Rezoning Application: PD 21-0626
Zoning Hearing Master Date: December 13, 2021
BOCC Land Use Meeting Date: February 8, 2022

AGENCY REVIEW COMMENT SHEET

AGENCY COMMENT SHEET

8.0 PROPOSED SITE PLAN (FULL)

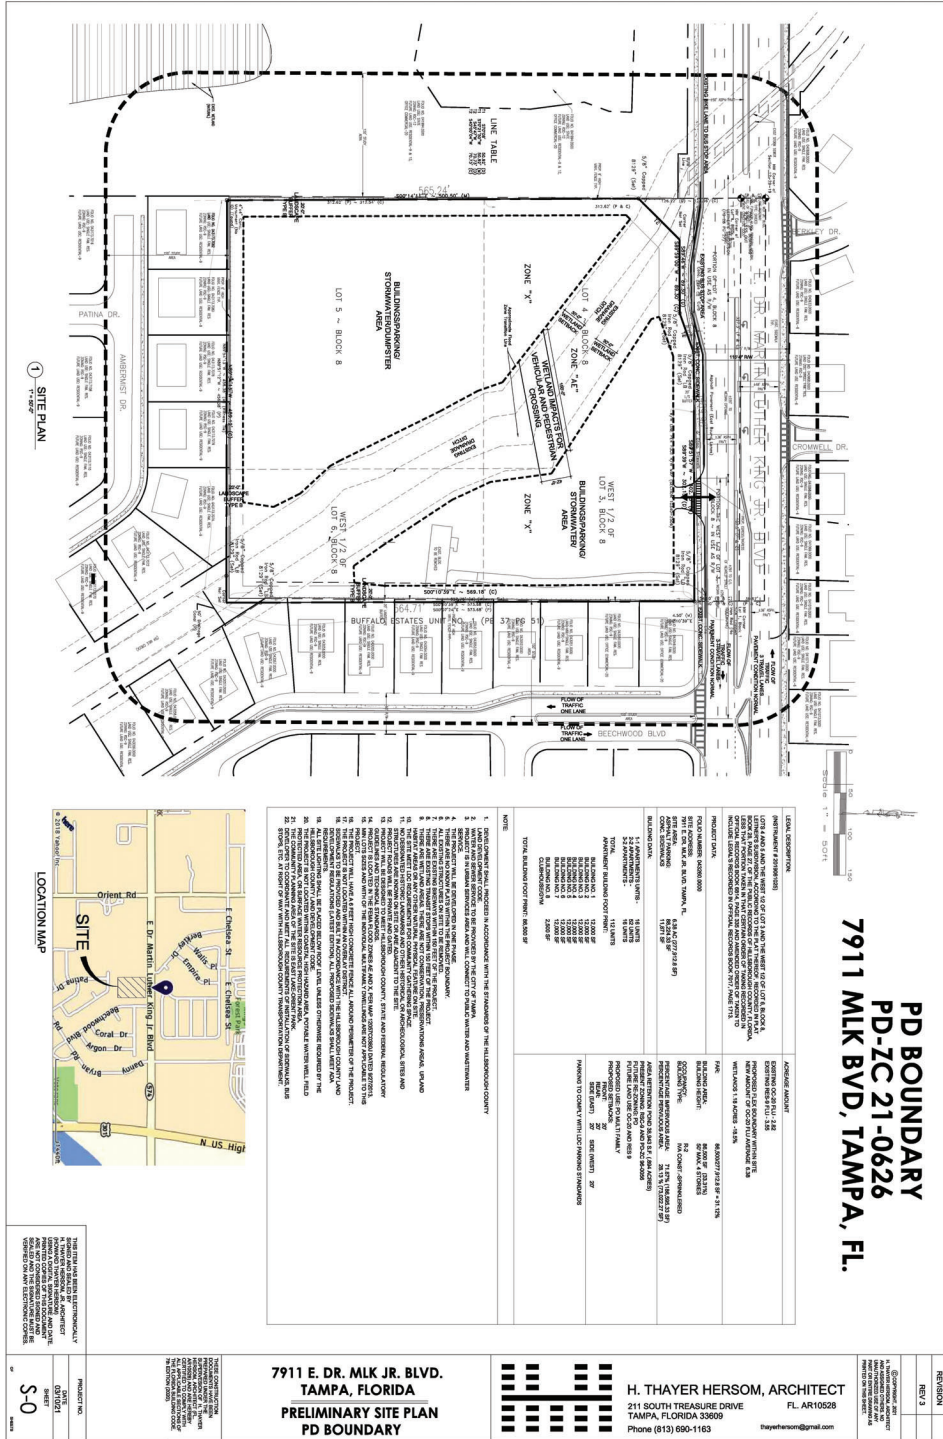
1. Notwithstanding anything herein these conditions or on the PD site plan to the contrary, bicycle and pedestrian access may be permitted anywhere along the project boundaries.

2. The developer shall construct an internal sidewalk system which complies with LDC requirements and connects both sides of the project across the wetland (labeled as “existing drainage ditch” on the PD site plan”).

- Prior to PD Site Plan Certification, the developer shall revise the site plan to:
 - Modify note 12 such that it reads, “Project driveways shall be private and may be gated. If gated, project shall comply with TD-9 gate standards as shown in the Transportation Technical Manual (TTM).

**PRELIMINARY SITE PLAN
TAMPA, FLORIDA**
7911 E. DR. MLK JR. BLVD.
PD BOUNDARY

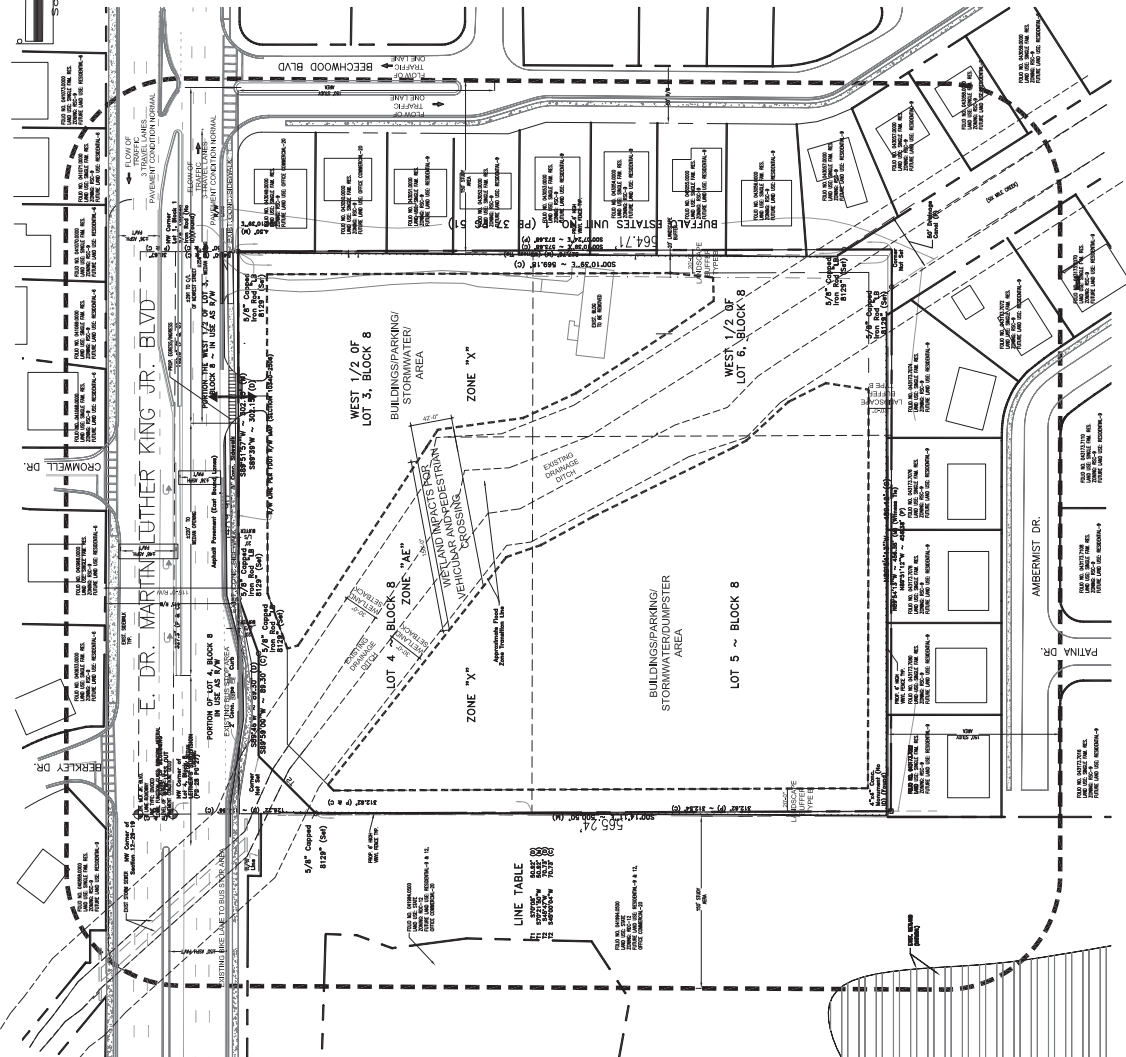
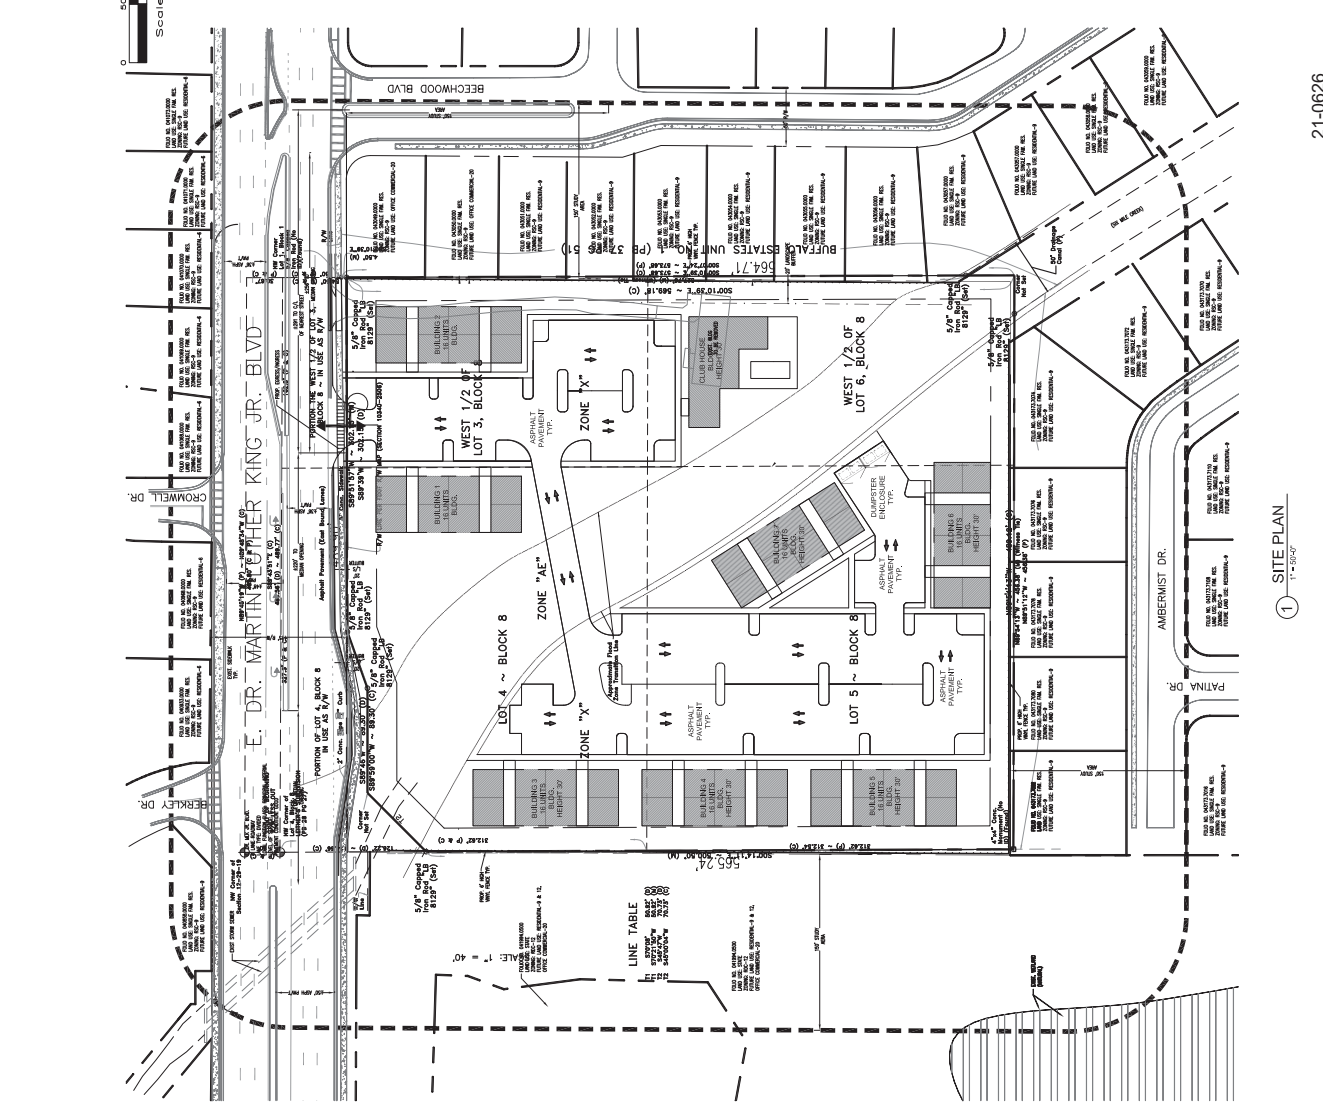
8. Light poles will need to be relocated to back of sidewalk. NOT in the sidewalk. Existing and relocated locations both need to be labeled on the plans.

11. All FDOT drainage pipe and structures need to be shown in plans.
12. Show flood stage of creek after additional project stormwater is included.
13. ADA compliant sidewalk routes need to be provided throughout the site and tie into a connection to the state road.

16. Remove all other existing driveways and restore the existing curb line.
17. Maintain 20' pedestrian sight triangles and draw the triangles on the plans to show there are no obstructions taller than 24" within the triangles. (See example below)

Driveways leading onto state roads need to have min. 20' x 20' clear 'pedestrian sight triangles' on each side of the driveway, at the edge of the sidewalk. It should be measured as 20' up the sidewalk and 20' up the driveway from the point at which the sidewalk meets the driveway. Nothing above 2' in height from the pavement elevation (except for the stop sign post) should be placed in these triangles. Also, no parking spaces should be in these triangles, not even partially. Please draw in and label these 'pedestrian sight triangles' on the plans. Here is an example of what these triangles look like and how they are positioned (see red triangles in the attached example)

MLK TSM&O recommended converting median opening to EB directional and remove WB u-turn.
